**ASHLAND PLANNING DIVISION
PRE-APPLICATION CONFERENCE
COMMENT SHEET** May 7, 2025

SITE: 44 Scenic Dr. (TLs 5701,7302)
APPLICANT: Rogue Planning
REQUEST: Land Partition/PLA

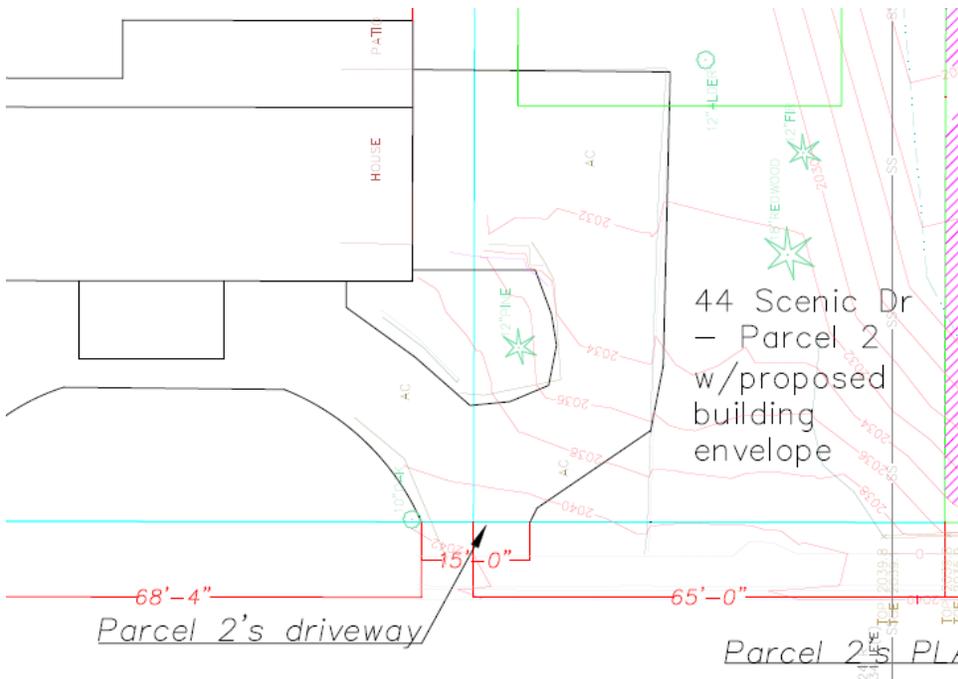
- **While unconventional the proposed easement to lot two appears to conform with the standard at AMC 18.5.3.060. D** “...Drives shared by adjacent properties shall have a width of 20 feet, with a 15-foot paved driving surface. Width shall be increased on turns where necessary to ensure fire apparatus remain on a paved surface during travel.”

The existing driveway is far wider than the maximum allowed and will need to be reduced in width. Based on aerial maps staff believe that the width of the existing driveway is roughly 30’ wide. The drawing below indicates that the driveway is 15’ in width when it is twice that.
